UD TRUCKS TECHNICAL BULLETIN # TR - 10 (Rev.)

DATE: FEBRUARY 27, 1998
MODEL YEAR: 1995 AND AFTER
CHASSIS MODEL: UD1400
BULLETIN #: TR - 10 (Discard previous bulletin TR - 10 dated 01/31/97.)
FILE IN THE TRANSMISSION SECTION OF THE TECHNICAL BULLETIN BINDER

JATCO ATM REVERSE PRESSURE TEST PORT LOCATION CHANGE

**FOR JATCO SERIAL NUMBERS
4184686 AND AFTER**

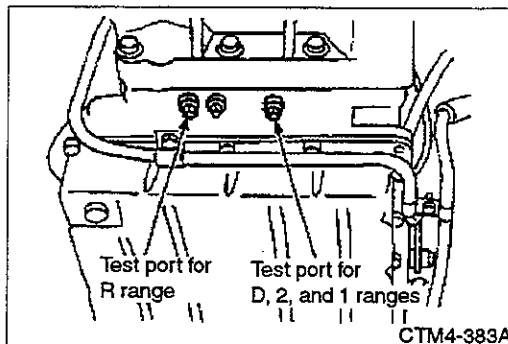
Page AT-5-64 incorrectly indicates the location for the JATCO automatic transmission reverse pressure test port for all UD1400 trucks. The location of the reverse pressure test port changed starting with JATCO serial number 4184686.

The illustration to the left correctly indicates the location of the reverse pressure test port (1/8" BSPT) for all UD1400 trucks with JATCO serial numbers **AFTER** 4184686.

The UD Dealer must locally purchase a fitting to adapt the existing pressure test gages to this port until Kent-Moore ships the proper adapter hose for the 1/8" BSPT port. Refer to Technical Bulletin TL - 10.

**FOR JATCO SERIAL NUMBERS
BEFORE 4184686**

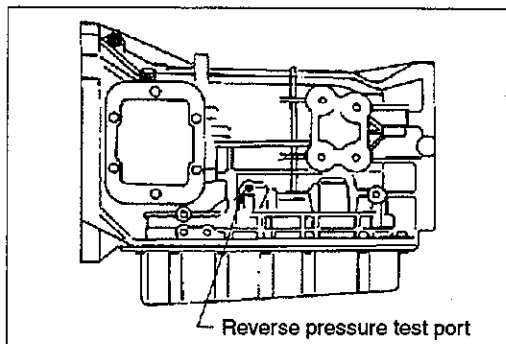
The illustration below, on UD1400 Service Manual page AT-5-64, correctly indicates the location of the reverse pressure test port for all UD1400 trucks with JATCO serial numbers **BEFORE** 4184686:

- Location of line pressure test port (1/4" BSPT).
- **Always replace line pressure plugs as they are self-sealing bolts.**
